Hi-Fi Products Service Bulletin

Model: CDP-H3600

No. 367

Subject: Preventing Damage To Q101

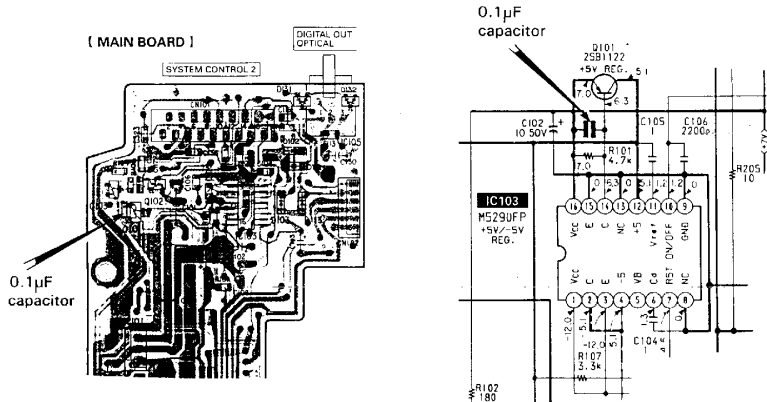
(**) The unit has no power because Q101 on the Main MCB is damaged.

Replace Q101, and prevent it from being damaged again by adding a 0.1µF capacitor across its base and emitter.

This capacitor has already been mounted on *some* version "A" Main boards, and *all* version "C" Main boards. Version "A" Main boards are silkscreened with the number 1-638-990-__; version "C" Main boards are silkscreened with the number 1-640-541-__. Add the capacitor only to version "A" Main boards which do not already have the capacitor mounted.

REF	DESCRIPTION	PART NUMBER
Q101	TRANSISTOR, 2SB1122S	8-729-804-41
-	CAPACITOR, CHIP, 0.1µF	1-163-038-00
